Access Compliance Report

Public Rights-of-Way

(Curb Ramps)

Intersection ID: 7129	Main Street: DAWNSHIRE_AV	Cross Street: NORTHBROOK_DR	Location: NW
ADA ID: 6AFA8A11CD54	Ramp Type: Perp	Initial Pass/Fail: Fail	Overall Compliance: No
		Severity Score: 12.5

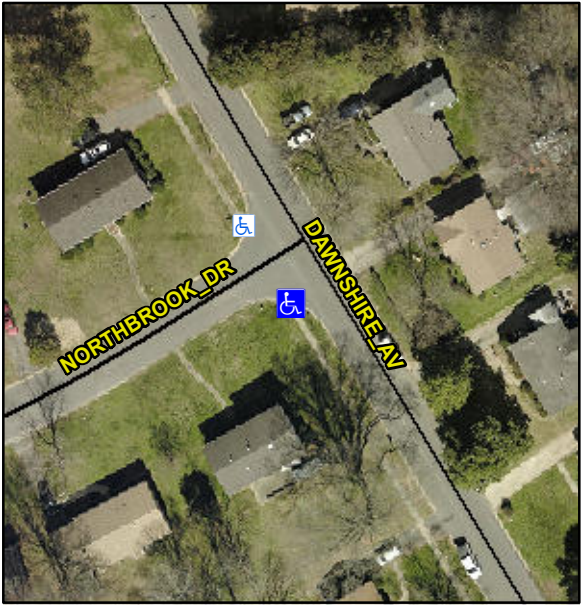
Codes/Mitigation Info/Possible Solution		Field Measurements/Component Compliance					
	Possible Solutions:	Compliance	Description	Data	Compliance	Description	Data
	Remove & Replace Entire Ramp.	N/A	Ramp Length (in)	38.0	Yes	Ramp Slope (%)	6.1
		Yes	Ramp Width (in)	48.0	No	Ramp XSlope (%)	6.8
		N/A	Flare Type LT	N/A	N/A	Flare Type RT	N/A
		N/A	Flare Slope LT (%)	N/A	N/A	Flare Slope RT (%)	N/A
		N/A	Flare Traversable LT?	N/A	N/A	Flare Traversable RT?	N/A
		N/A	Landing Length (in)	N/A	N/A	DWS Provided?	N/A
		N/A	Landing Width (in)	N/A	N/A	DWS Contrast?	N/A
		N/A	Landing Slope (%)	N/A	N/A	DWS Length (in)	N/A
		N/A	Landing X Slope (%)	N/A	N/A	DWS Full Width?	N/A
		N/A	Landing Curb? (Y/N)	N/A	N/A	DWS Offset (in)	N/A
		N/A	Shared Landing?	N/A			
		N/A	Gutter Ponding?	N/A	N/A	Gutter Slope (%)	N/A
		N/A	Gutter Lip Ht (in)	N/A	N/A	Gutter X Slope (%)	N/A
		N/A	Painted X Walk1?	No	N/A	Painted X Walk2?	N/A
			X Walk 1 Direction	To NW		X Walk 2 Direction	N/A

N/A	X Walk 1 Width (in)	N/A	N/A	X Walk 2 Width (in)	N/A
			X Walk 1 Slope (%)	7.3		X Walk 2 Slope (%)	N/A
			X Walk 1 X Slope (%)	3.2		X Walk 2 X Slope (%)	N/A
		N/A	Ramp inside XWalk1?	N/A	N/A	Ramp inside XWalk2?	N/A
<p>Surveyor Notes:</p> <p>N/A</p> <p>PROW/ADA:</p> <p>Not Found, R304.5.3</p>			Road Slope (%)	N/A	N/A	Clear Space?	N/A
			Road X Slope (%)	N/A	N/A	Clear Space to XWalk (in)	N/A
		N/A	Any Obstructions?	N/A	N/A	Storm Grate/Utility Hazard?	N/A
			Obstruction Type			Storm Grate/Utility Type	
				N/A			N/A
					Yes	Surface Condition? (G/P)	Good
Total Cost:		\$	1850.00
